ITEM # 2.1

PRELIMINARY & FINAL PLAT APPROVAL:

Washington Lots Subdivision
Being a 0.97 acre tract of land more or less, being
the south 845' of the west 1 acre, Lot 92 Mission
Acres
R-1
Developer:
Engineer: South Texas Infrastructure Group

WASHINGTON LOTS SUBDIVISION

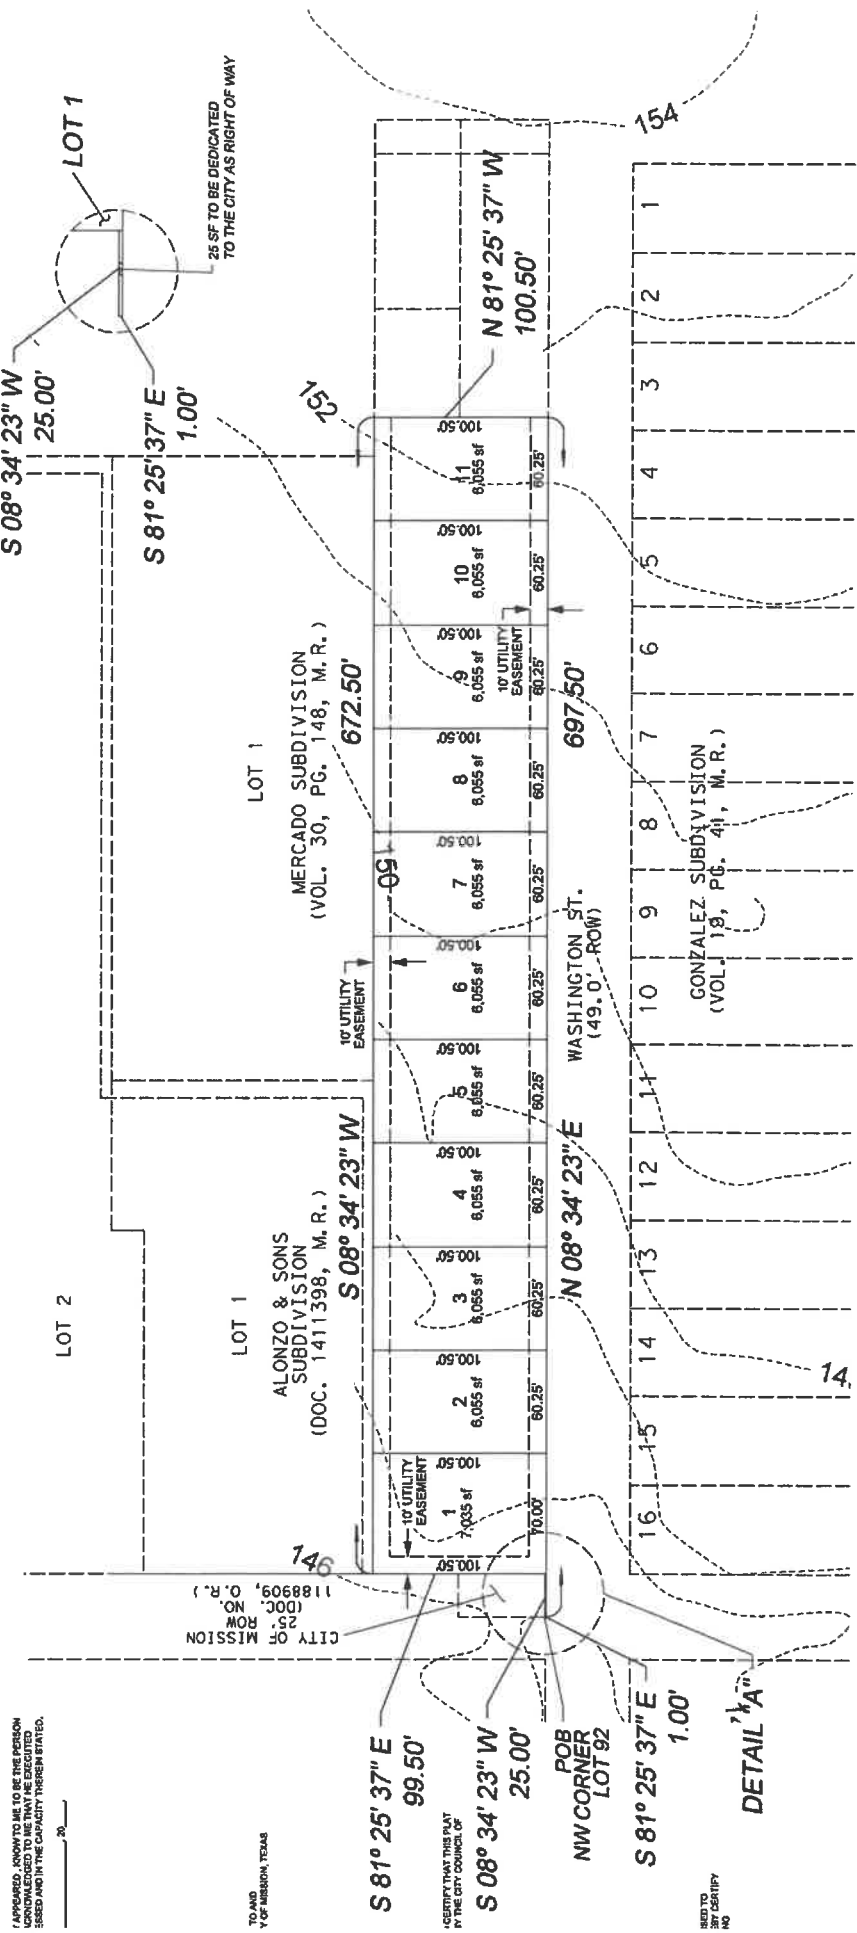
This property is located on the northeast corner of the intersection of Blake Ave. and Washington St. — see **vicinity map**. The developer is proposing a 11 Lot residential subdivision. Currently, the land is vacant — see plat for actual dimensions, square footages, and land uses.

Water will be supplied by a proposed 8" water main line located along the east side of Washington St. to include a fire hydrant. The line will connect to an existing 8" main perpendicular on Blake Ave. and looped to an existing line along W. 18th St. — see **utility plan**

A proposed 8" sanitary sewer line will be made available to service each lot which will be installed within a 10' utility easement located at the rear, east of the development. The line will connect to an existing 8" sewer line from W. 18th St. and run south ending at a proposed cleanout. The Capital Sewer Recovery Fee is required at \$200.00/Lot which equates to \$2,200.00 (\$200.00 x 11 lots).

Access to the proposed Lots will be from Washington St. The post development volume of storm water runoff is 5.99 cfs based on the 50-yr storm frequency. Approximately 4,283 cft or 0.098 ac-ft will need to be detained within the green areas of the proposed lots and overflowing into Washington St. This street eventually outfalls into a City of Mission Ditch located on the northeast corner of the intersection of Los Ebanos Rd. and W. Griffin Parkway. The City Engineer has reviewed and approved the drainage report.

Payment of Park Fees in the amount of \$5,500.00 (\$500 x 11 lots)
The development has existing Street Lighting as per City Standards
Must Comply with all other format findings

Staff recommends approval subject to:

1. Payment of Capital Sewer Recovery Fees
2. Payment of Park Fees
3. Comply with all other format findings.
